# EL PASO COUNTY LANDSCAPE CODE COMPLIANCE

**ROADWAY & BUFFER** NORTH/WEST LANDSCAPE LP-01

# LANDSCAPE PLAN - AREA 'E'

ORIGINAL DATE 5-22-17 DRAWN BY: **JM** DESCRIPTION:
AREA 'B' & 'E'
LANDSCAPE PLAN

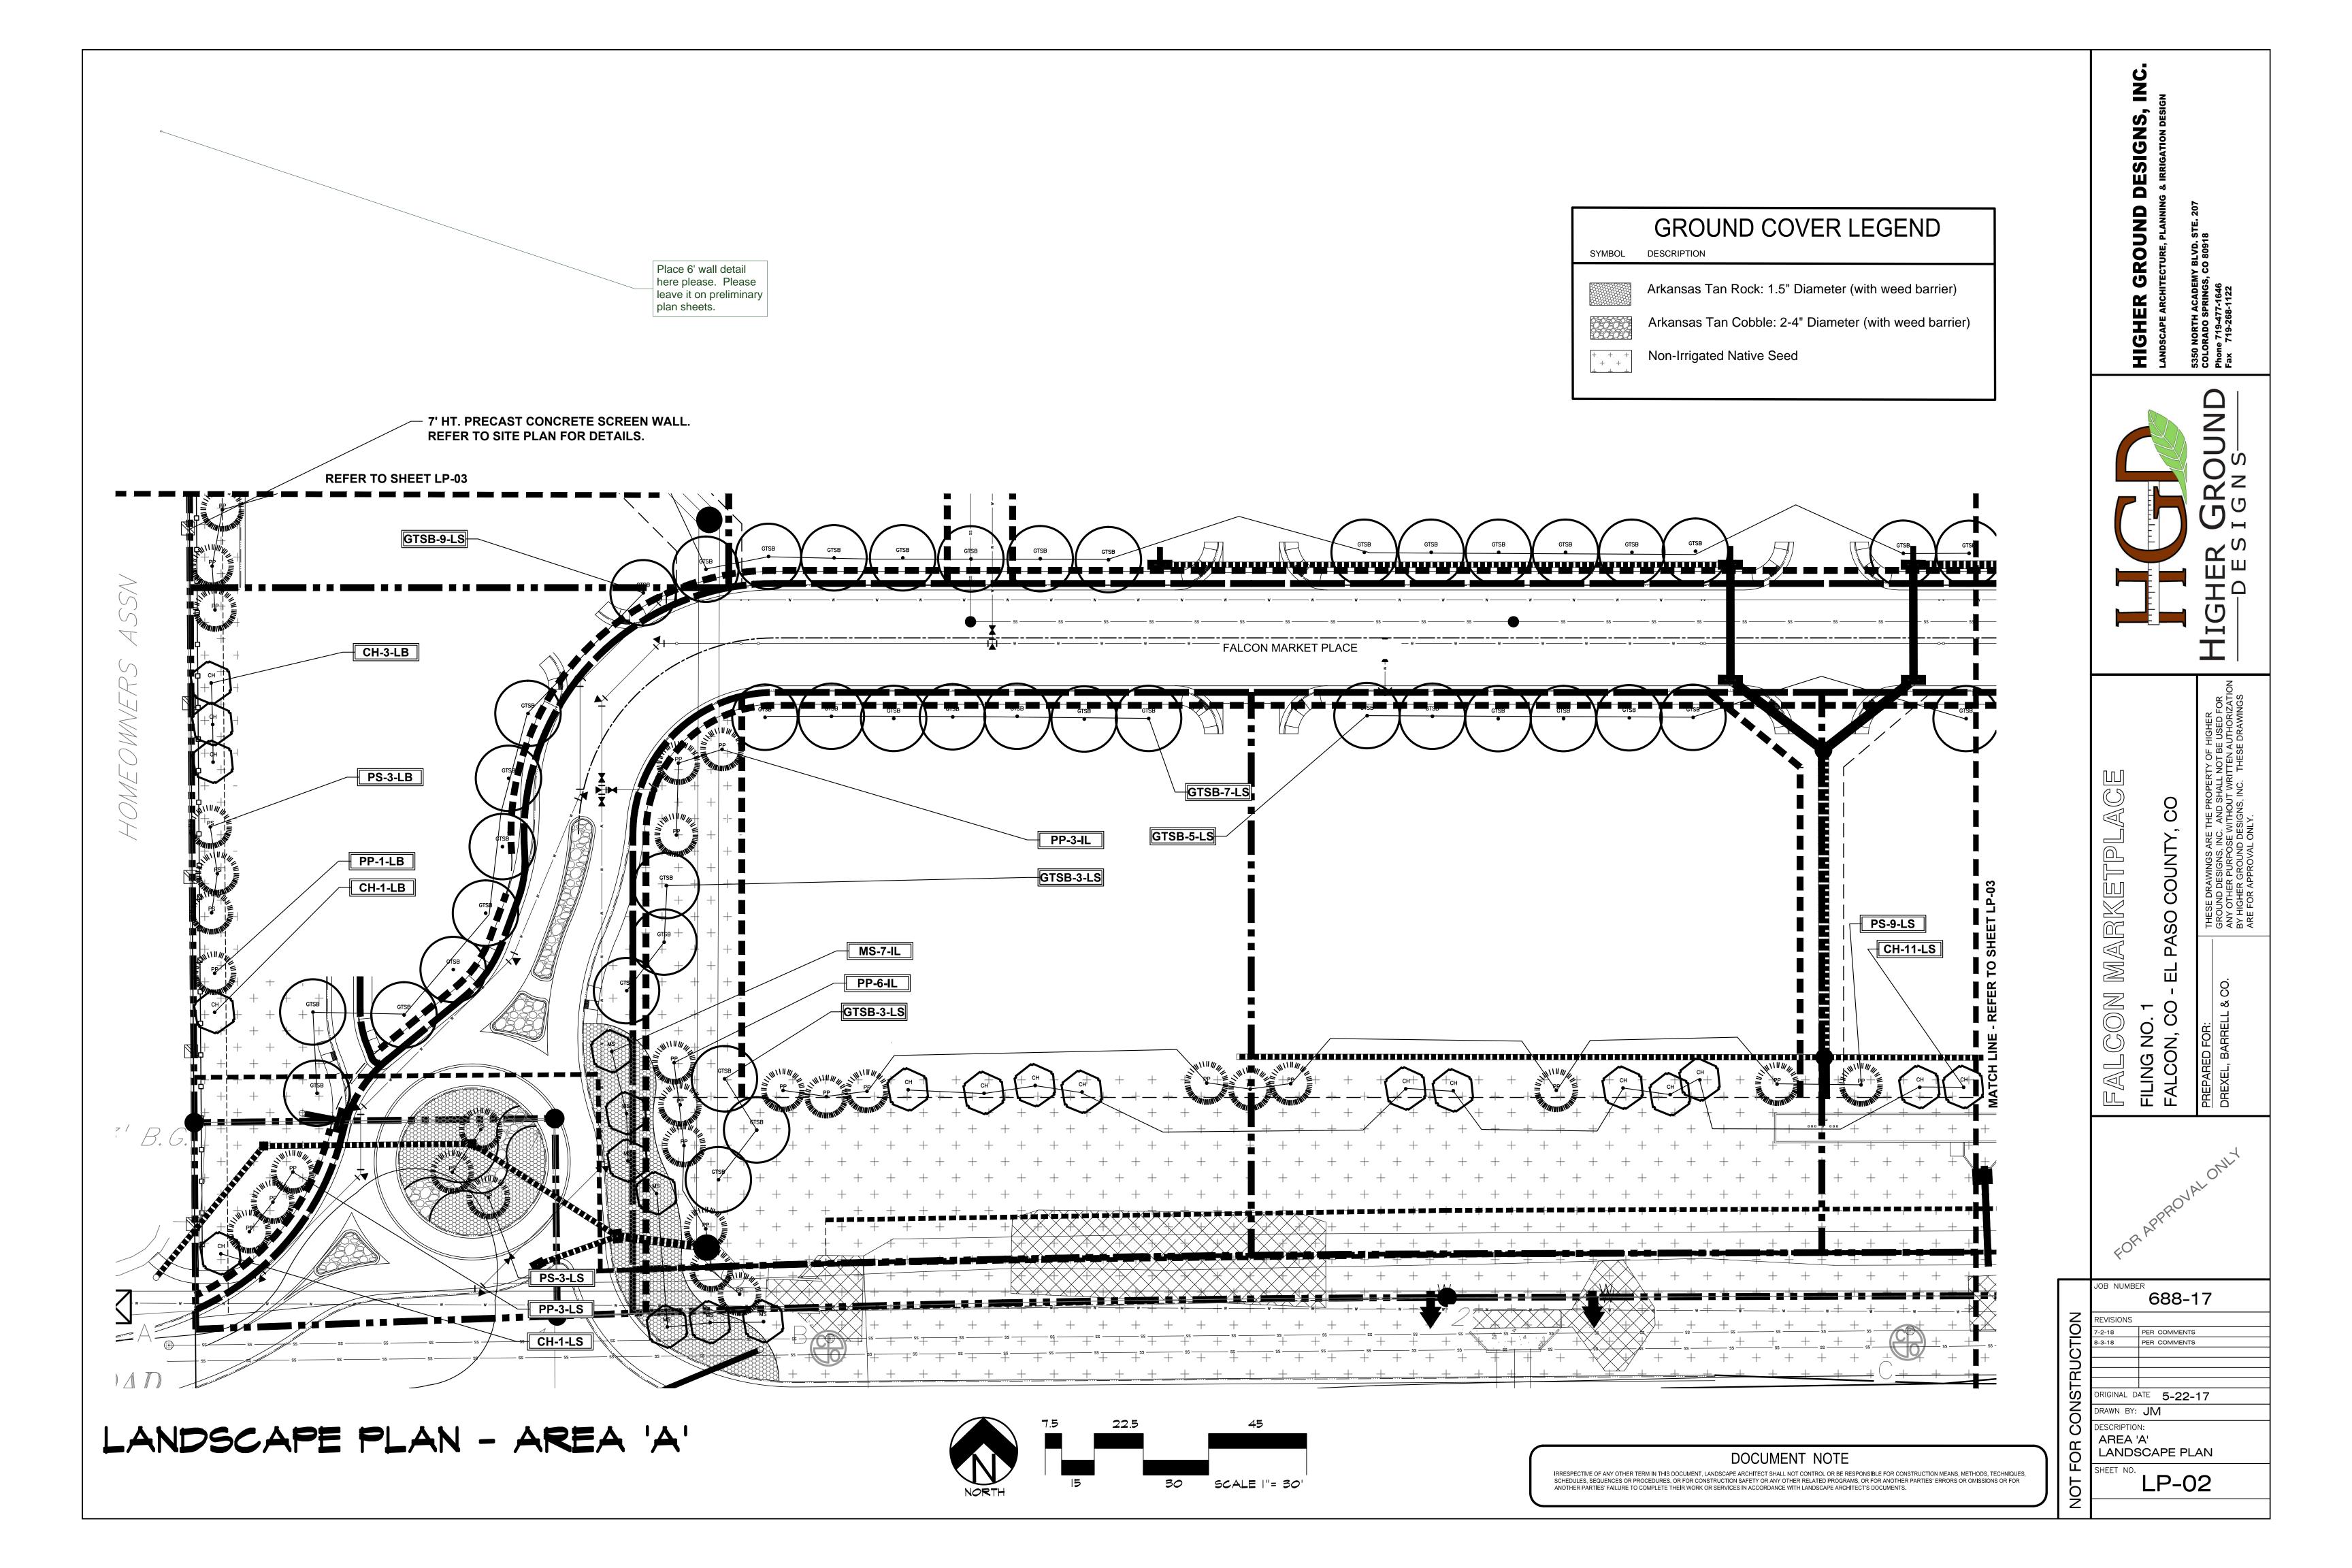
Applicant would like a 6' fence.

Provide area where these are to be shown. You can use clouds or leaders for a general location. Is this list your master list which future site dev plans

will incorporate? If so, please state.

LP-03

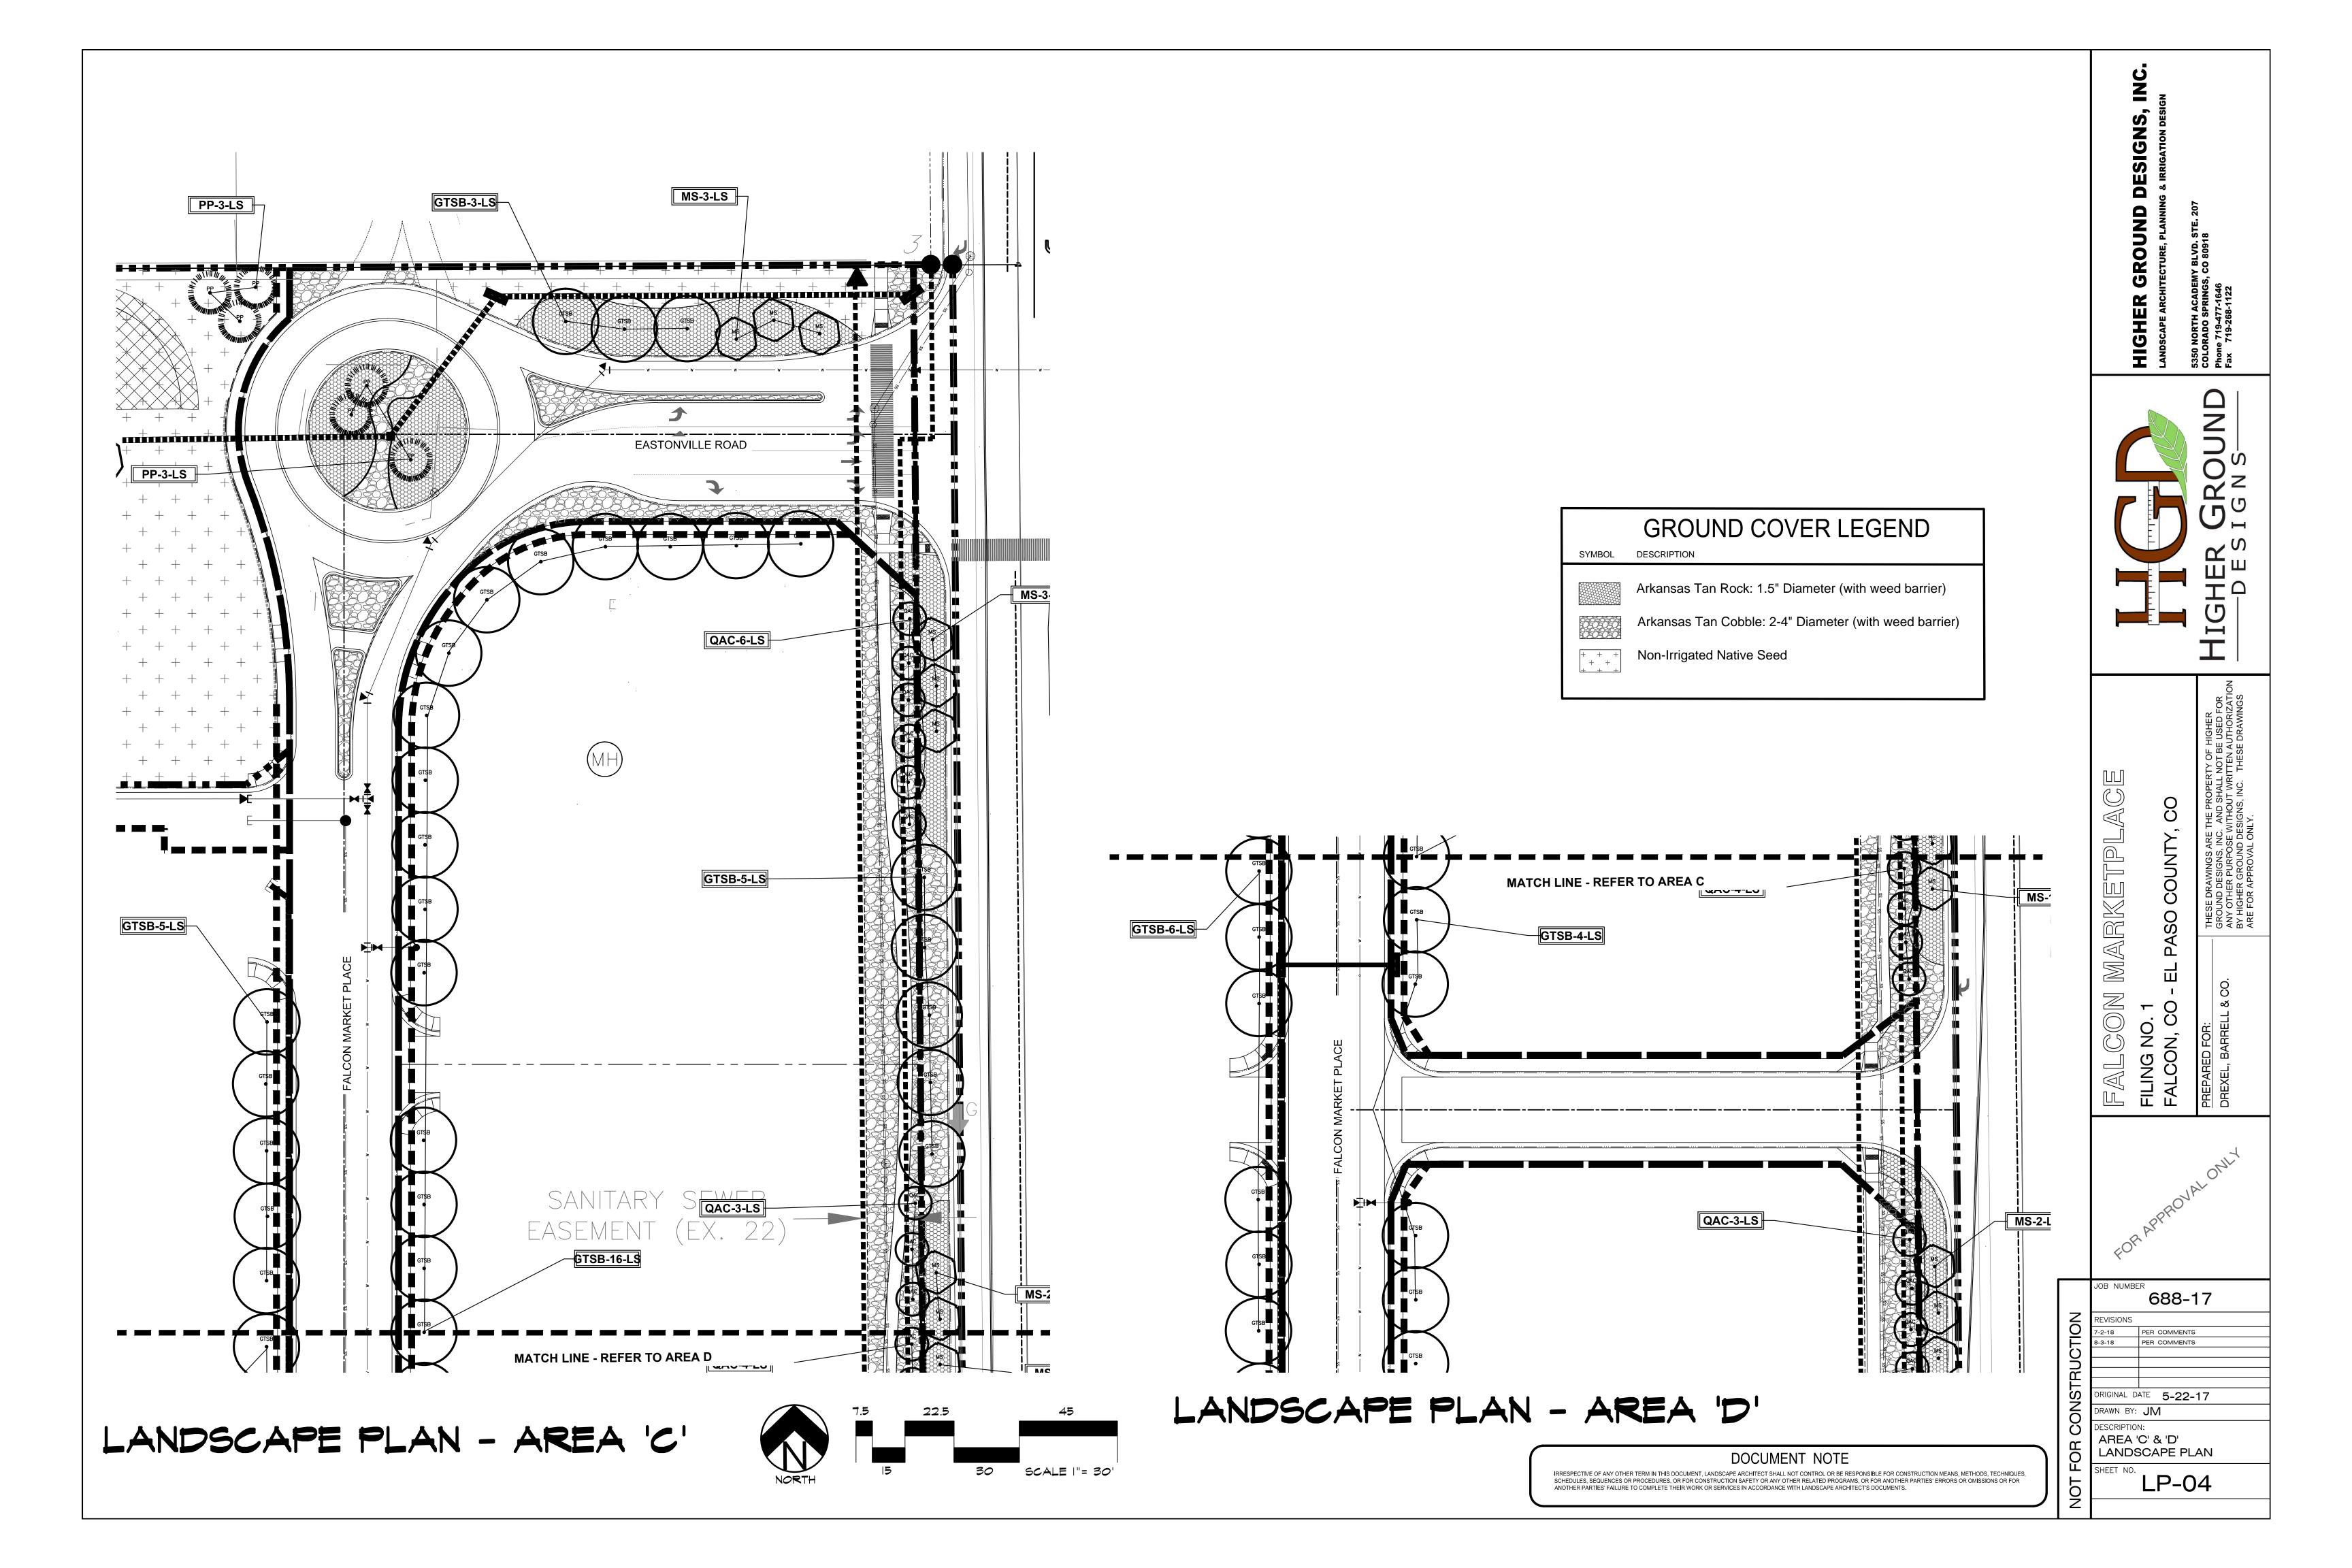
Place 6' wall detail here please. Please leave it on

preliminary plan sheets.
